UNITED STATES PATENT AND TRADEMARK OFFICE

APPLICATION NO.	FILING DATE	FIRST NAMED INVENTOR	ATTORNEY DOCKET NO.	CONFIRMATION NO.
10/643,071	08/18/2003	Paul Lum	10004024-2	4192

Office Action Summary

FIG. 6A

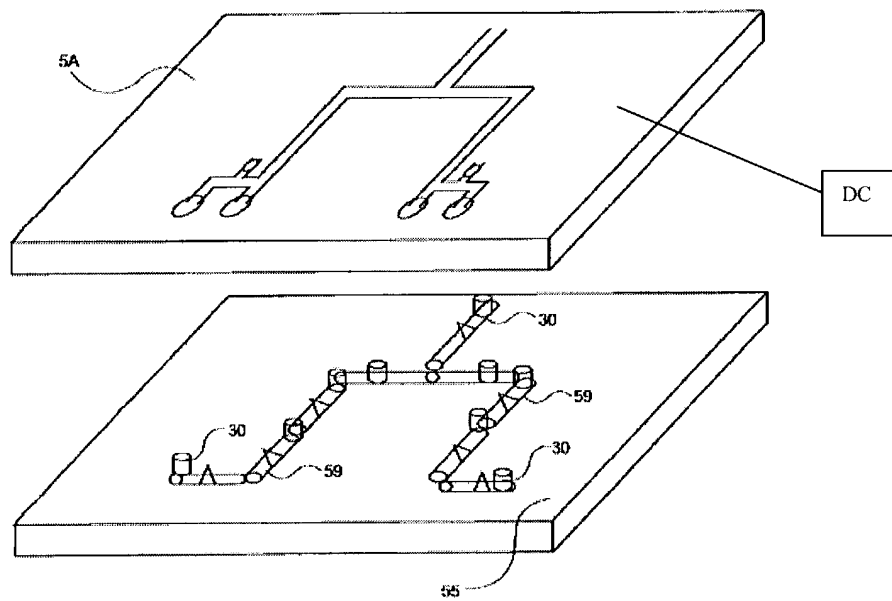
With respect to claim 1, **Kamholz** teaches a disposable cartridge DC comprising: a network of conduits 12, 14 and reservoirs 35, 37 within said cartridge, at least one micro-pump MP fluidly coupled to said network for transporting small volumes of biological fluid, said pump comprising: a rotatable portion having a magnetic core 30m and configured to be rotatable by alternating inductive magnetic fields to urge fluid through said network. See particularly **Figures 6A, 10** and column 1 lines 22-24 of Kamholz.

With respect to claim 6, **Kamholz** teaches a device comprising: a disposable cartridge DC, a network of conduits 12, 14 and reservoirs 35, 37 within said cartridge; a micro-pump MP fluidly coupled to said network for transporting small volumes of biological fluid, said pump comprising a rotatable portion configured to be rotatable by alternating inductive magnetic fields to urge fluid through said network; an external electromagnet (column 3 lines 37-38; column 4 lines 47-49; column 9 lines 25-26) providing said alternating inductive magnetic fields for causing the rotatable portion to move to transport small volumes, said electromagnet positioned external of said disposable cartridge and fluidically isolated from said micro-pump. See particularly **Figures 6A, 10** of Kamholz.

With respect to claim 7, **Kamholz** teaches that said electromagnet is reused with successive disposable cartridges and the rotatable portion is contained in the cartridge and does not contaminate the electromagnet. See particularly **Figures 6A, 10**; column 3 lines 37-38; column 4 lines 47-49; column 9 lines 25-26 of Kamholz.

With respect to claim 9, **Kamholz** teaches the actual pumping mechanism of the micro pump is completely isolated from said external electromagnet. See particularly **Figures 6A, 10**; column 3 lines 37-38; column 4 lines 47-49; column 9 lines 25-26 of Kamholz.

Kamholz teaches that the invention can be used for several applications such as: biomedical, medical (i.e., blood, medicine, etc), biothechnical, etc. **Kamholz** does not teach that the rotatable portion does not exceed the level that the level that would puncture or damage the blood cells. However, it is well known in the art that one design consideration when designing a blood pump is to prevent the pump from degrading the quality of the blood by damaging the blood cells. Therefore, it would have been obvious to one of ordinary skill in the art at the time the invention was made to have designed **Kamholz's** rotatable portion in a way that it would have not damage the blood cells so as to prevent degradation of the quality of the blood being pumped to a patient. See particularly **Figures 6A, 10** and column 1 lines 22-24 of Kamholz.
